# **Staff Report**

····· ····· ···	
To:	Salt Lake City Planning Commission
From:	Krissy Gilmore, Senior Planner, <u>kristina.gilmore@slcgov.com</u> or 801-535-7780
Date:	December 8, 2021
Re:	PLNPCM2021-00533 – Detached Accessory Dwelling Unit

# **Conditional Use**

PROPERTY ADDRESS:	1849 East 1300 South
PARCEL ID:	16-09-478-020-0000
MASTER PLAN:	East Bench – Neighborhood Node
<b>ZONING DISTRICT:</b>	R-1/5,000 Single-Family Residential and the Yalecrest Compatible
Infill Overlay Zone

Figure 2. ADU and Garage Elevations

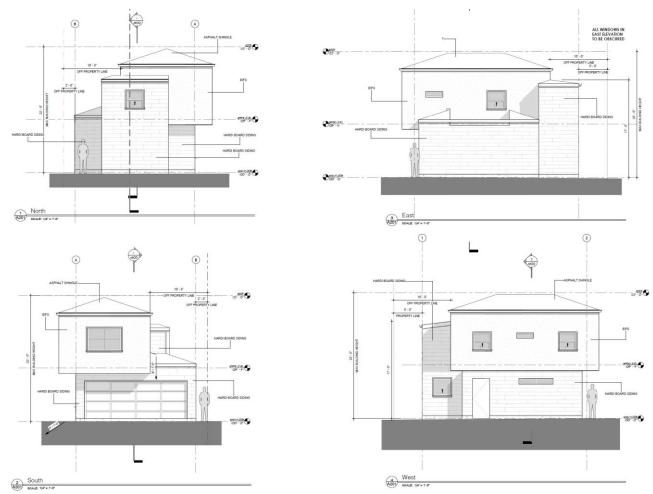
The proposed ADU is located within the Yalecrest Compatible Infill Overlay Zone (YCI). While the overlay zone has stricter accessory building zoning requirements than the ADU ordinance, ADU's are not subject to the YCI accessory building requirements due to the specific language in the ADU ordinance bolded below. While the YCI speaks to conflicts between the YCI and the underlying zoning district, and that the stricter YCI standards would prevail, it does not speak to other sections of the code, such as the ADU ordinance. Meaning the ADU standards are found in a different chapter of the code and the YCI standards are not applicable.

Therefore, the proposed ADU may be equal to the height of the single-family dwelling on site, up to a maximum of 24'. In this case, the single-family dwelling is 22' and the ADU is also proposed at 22'. The ADU must be setback 10' from the side and rear property lines, which is why the ADU is cantilevered, as the applicant intends to keep the existing footprint of the garage.

Note that the house has a hipped roof and the height of the side walls is much less than 22'. A garage/2nd story ADU with a 22' height on that site is clearly an incompatible design. Other houses on the street face are similar in design and height. Coty code clearly states that the ADU should be Inferior in height to the principal housing structure. The effective side wall height is much less than 22'.

-The code provided clearly states that the ADU must be inferior to the principal structure in height. The house height is 22', so the ADU height must be less than 22'. From the code and your experience on approved ADUs of 22' or higher, would dictate that the principal dwelling structure (house) be 2 stories of greater than 22' That is NOT the case in the proposed ADU scenario

ADU Ordinance 21A.40.200.E.3.a. Bulk Requirements: Shall comply with all applicable general yard, bulk, and height limitations found in section <u>21A.40.050</u> of this chapter and any accessory building regulation found in the underlying zoning district or any applicable overlay zoning district <u>unless otherwise regulated by this section</u>.

Thank you for your comments. I have saved them as part of the public record for the project. The height at the ridge of the roof of the house is 22'. After discussing with the Zoning Administrator and the City Attorney's Office, it was determined that while the overlay zone has stricter accessory building zoning requirements than the ADU ordinance, ADU's are not subject to the YCI accessory building requirements due to the specific language in the ADU ordinance bolded below. While the YCI speaks to conflicts between the YCI and the underlying zoning district, and that the stricter YCI standards would prevail, it does not speak to other sections of the code, such as the ADU ordinance. Meaning the ADU standards are found in a different chapter of the code the YCI standards are not applicable.

1 SITE A001 SCALE: 1/8" = 1'-0"

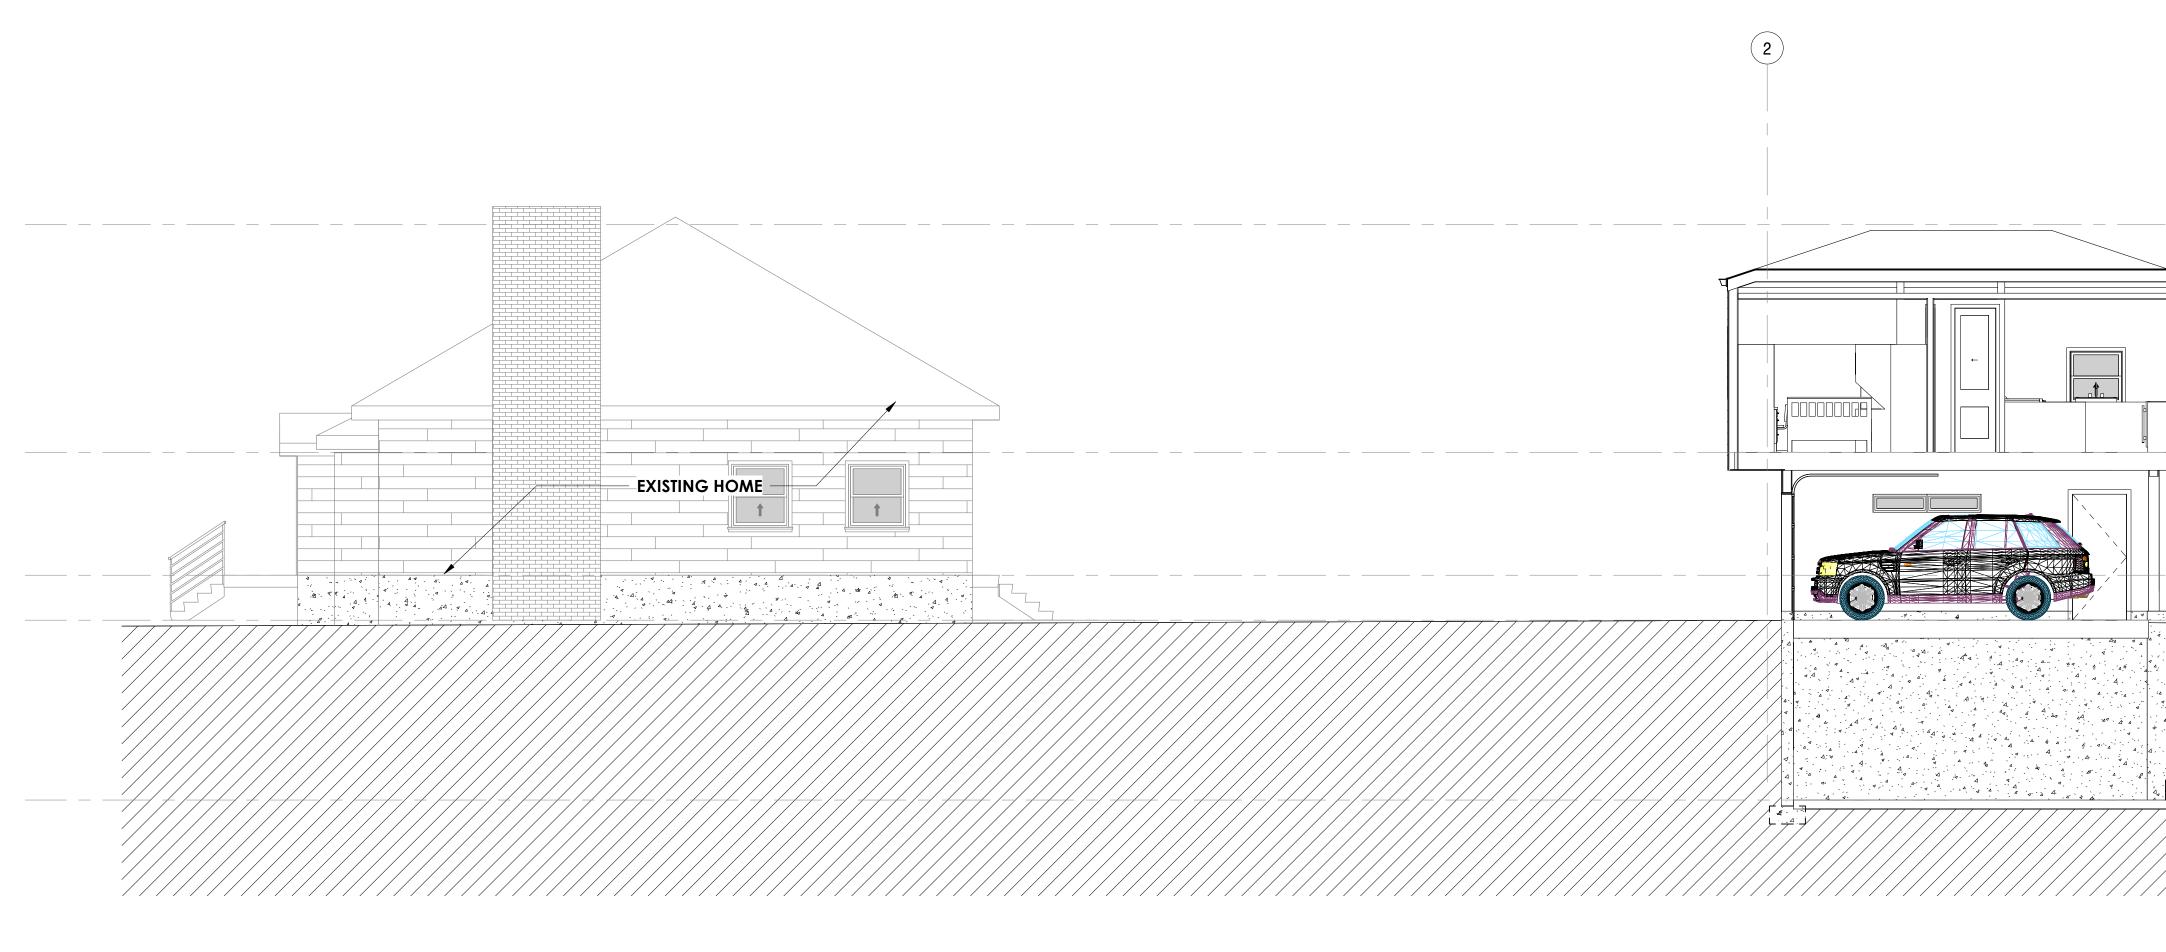
The Zoning Ordinance requires one (1) parking space for an ADU. The required parking space may be located on the property or on the street, if legal on-street parking space is available in the front of the property. In this case, the proposed parking for the ADU will be located onsite in front of the garage.
